Access Compliance Report Public Rights-of-Way (Curb Ramps)

Main Street: E_CHAPMAN_AVE Cross Street: HEWES_ST Location: NE

ADA ID: RPRK211223132536 Ramp Type: Type 1 - Perpendicular Initial Pass/Fail: Pass Overall Compliance: No Severity Score: 2

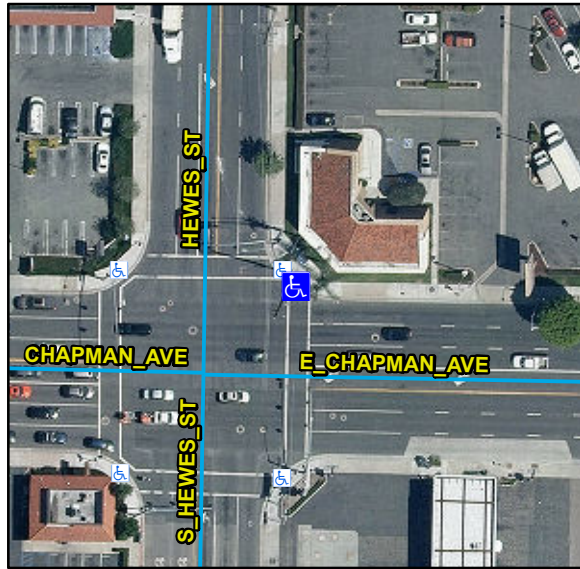
Remove & Replace Landing. Gutter Ponding Observed. Utility Present.

Compliance	Description	Data	Compliance	Description	Data
Yes	Obstructions Present?	No	N/A	Utilities Present?	Yes
	Obstruction Types	N/A		Utility Types	
	Obstruction Dimensions	N/A		Traffic Signal Pole

Yes	Ramp Inside Crosswalk 1	Yes	Yes	Ramp Inside Crosswalk 2	N/A
	Crossing 1 Slope (%)	3.7		Crossing 2 Slope (%)	N/A
	Crossing 1 Cross Slope (%)	0.5		Crossing 2 Cross Slope (%)	N/A
No	Gutter Ponding	Yes	Yes	Curb Slope	2.7
Yes	Gutter Lip Height (in)	0		Road Run Slope (%)	N/A
Yes	Gutter Run Slope (%)	4.8		Road Cross Slope (%)	N/A
Yes	Gutter Cross Slope (%)	0.2			
Yes	Overall Surface Condition: Acceptable		Yes	Perp Joint Present	Yes
	Cross Gutter Present?	No		Spandrel Present?	No
	Replace Cross Gutter?	N/A		Replace Spandrel?	N/A

Possible Solutions:

R304.2.1, R304.5.3, R302.7, STD 1115
